Location/Beam	Dimensions	Decay viewed from bearing side	Cross plan view	Photographs	Confirmed agreed repairs with Structural engineer comment in bold
Q/GB/1 Bearing end into external wall	95mm 270mm Bearing end Decayed section		 Cross plan view	Small pocket of wet rot 25mm deep approx. 25x25mm in section 	Recommendations Defrass the beam of all decay back to sound timber and treat with Wykamol 10.1 fungicide gel Confirmed repairs/treatments in email from Buro Happold dated 4-09-2024
Q/GB/1 Bearing end opposite GB2	95mm 270mm Bearing end Decayed section		 Cross plan view	Superficial rot to face of gutter beam 	Recommendations Defrass the beam of all decay back to sound timber and treat with Wykamol 10.1 fungicide gel Confirmed repairs/treatments in email from Buro Happold dated 4-09-2024
Q/GB/2 Bearing end opposite GB1	95mm 270mm Bearing end Decayed section		 Cross plan view	Wet rot to bearing end opposite GB1. Pocket of decay 150mm x300mm to depth of 25mm 	Recommendations Defrass the beam of all decay back to sound timber and treat with Wykamol 10.1 fungicide gel Confirmed repairs/treatments in email from Buro Happold dated 4-09-2024 <i>Defrass and treat is Ok. Section is adequate

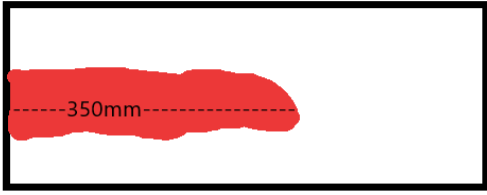
Q/GB/3 Bearing end opposite GB2	95mm 270mm Bearing end Decayed section		 Cross plan view	Decay 2/3 depth of beam to 600mm bearing . 	Recommendations Flitch beam plate repair as per drawings and calculation provided by WMI Consulting drawing no 1179R Confirmed acceptance of repair in email dated 27-09-2024 from Buro Happold

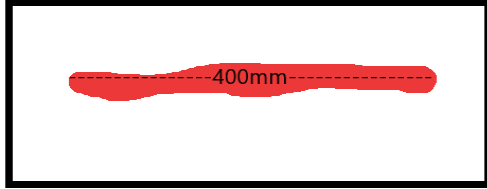
Location/Beam	Dimensions	Decay viewed from bearing side	Cross plan view	Photographs	Confirmed agreed repairs with Structural engineer comment in bold
M/VB/12 Bearing end opposite VB10	95mm 270mm	300mm 120mm	rot to the heath of beam 50% depth 300x120mm		Query from Buro Happold The bearing end is probably ok in shear. An alternative here is probably to remove the decayed material and infill with a timber packer Recommendations Robinsons substituted 1/2 lap repair for splicing in a new section after removal of decayed material
M/VB/11	100mm 275mm	Full beam length and depth of decay 30mm 50-60mm 50mm 20mm 15mm 10mm 40mm	Wet rot to varying depth the full length of beam		Recommendations Proposed treatments to be replaced with full replacement by Robinsons Confirmed repairs/treatments in email from Buro Happold dated 4-09-2024 Agree with replacement
M/VB/13	100mm 430mm	decay full length of beam to varying depth 20-50mm 30mm Plus 50mm 20mm 50mm	Wet rot to varying depth the full length of beam		Recommendations Proposed treatments to be replaced with full replacement by Robinsons Confirmed repairs/treatments in email from Buro Happold dated 4-09-2024 Agree with replacement

Notched purlin between gridline P&Q	Further to the removal of the former roof access between Gridline locations P . and Q, this has given a better understanding of how the roof was constructed This is the location of the notched purlin (see attached drawing and photo) . This section of roof was previously modified to accommodate the roof access. To provide the access, the original purlin (timber no 3) was cut at midspan onto a new trimmer (timber no 2) , a new bearer was installed which appears as a purlin from below (timber no 1) to support the trimmer and cut purlin. The new bearer (no1) was notched over the metal tie which was inset and already bolt plated to the upper purlin and lower purlin (no3) Half of the GB4 is missing after the installation of the roof access. A new section will be installed supported off the truss and steel beam	Recommnedations  Beam to remain in situ 1 2 3 Remove original purlin and save timber Remove trimmer Install new purlin C24 full width of bay	Further to meeting with Buro Happold verbal agreement was made on the proposed works. The SE required additional post supports below the the existing GB4 and the new section of GB4 Recommendations Remove the former roof access roof and beam no 1. Install new purlin to match existing section using C24 timber, fixed to outer wall with steel brackets. Infix the metal tie to the new and existing purlins. Allow to replace 1/2 of the missing gutter beam with C24 100x275mm treated timber with additional post support provided by C16 50x150mm timber coached screws to the gutter beam. Cover the new roof structure with 60x120mm common rafters
